Premises: 43-47 Kenneth Street, Longueville
Development Application No. 72/2023 – Alterations and Additions to an Existing Private Hospital

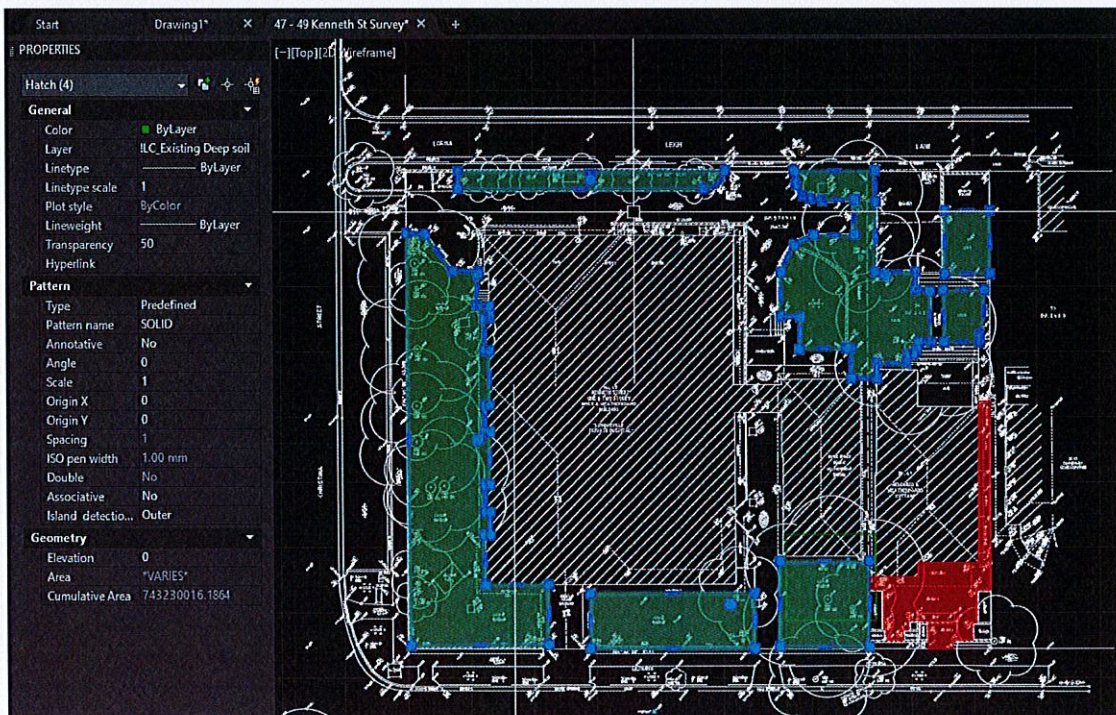
The above outcomes have contributed to the proposed further variation to LDCP Part C Part 1.5 – Landscaped Area where the proposed landscaped area is below the **minimum 35%** area required. You are advised that the proposed variation is not supported in this instance.

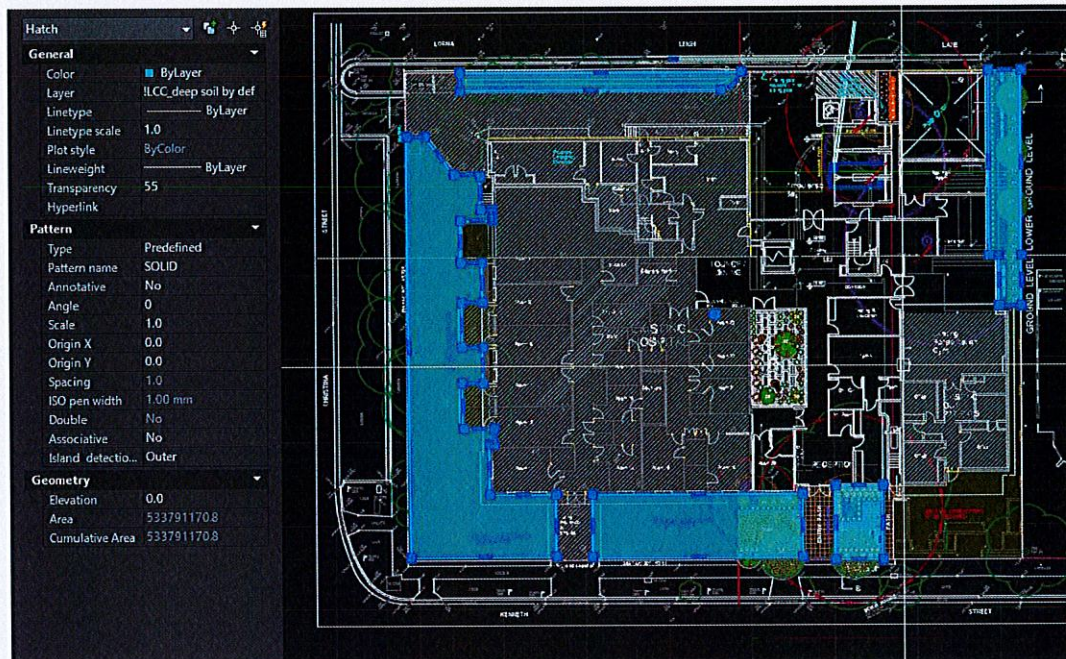
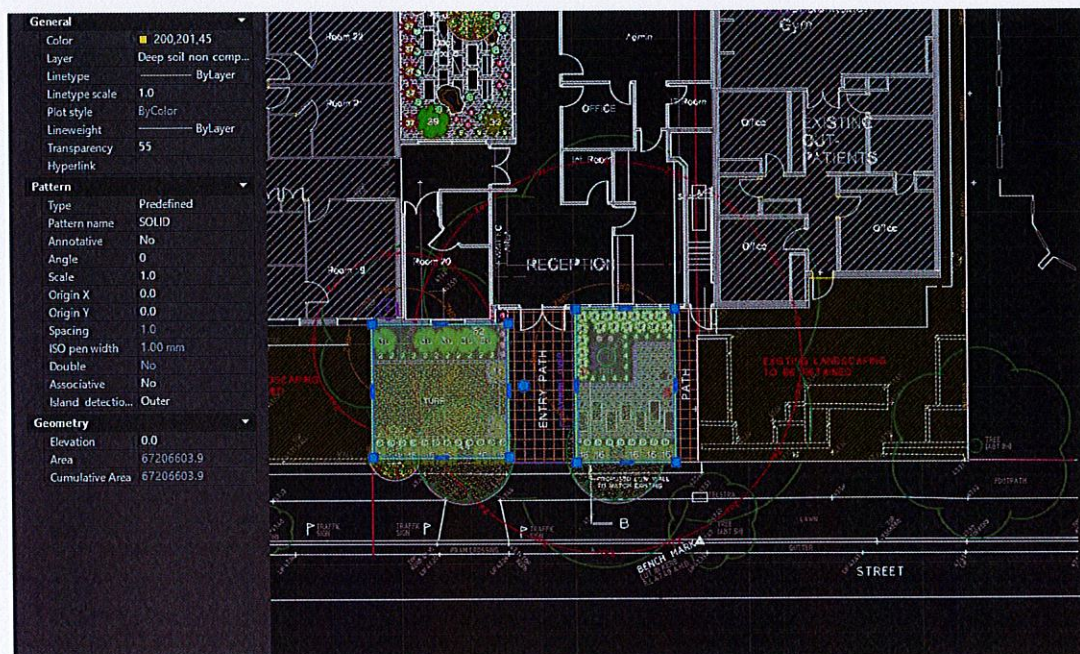
*The Landscape Concept Plan 23 036 DA 4 of 4 incorrectly calculates the area of deep soil landscaping as shown below resulting in a **shortfall of 14.84% or 393m²**:*

The green hatch areas represent the existing area to be counted as deep soil by Council = 743.23m² or 26.43%.

The red hatch area has been counted as deep soil incorrectly as this is all hardscape area = 83.13m².

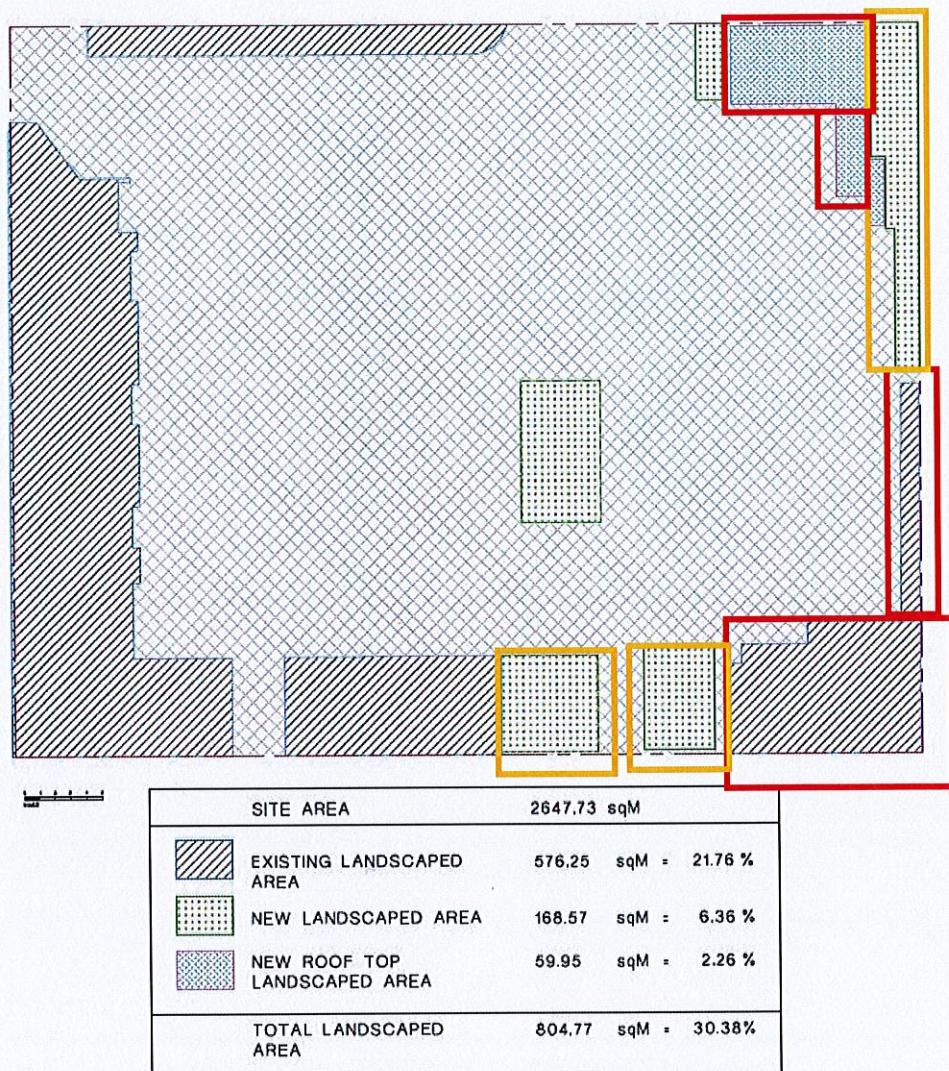
The green blue areas represent the proposed area to be counted as deep soil by Council = 533.97m² or 20.16%.

The proposed deep soil area along Kenneth St frontage 67.20m² a reduction of 92.71m².

The green hatch areas represent the existing area to be counted as deep soil by Council = 743.23m² or 26.43%.

= Area that does not meet the definition of deep soil

= Areas that are already counted as deep soil and are not new/additional
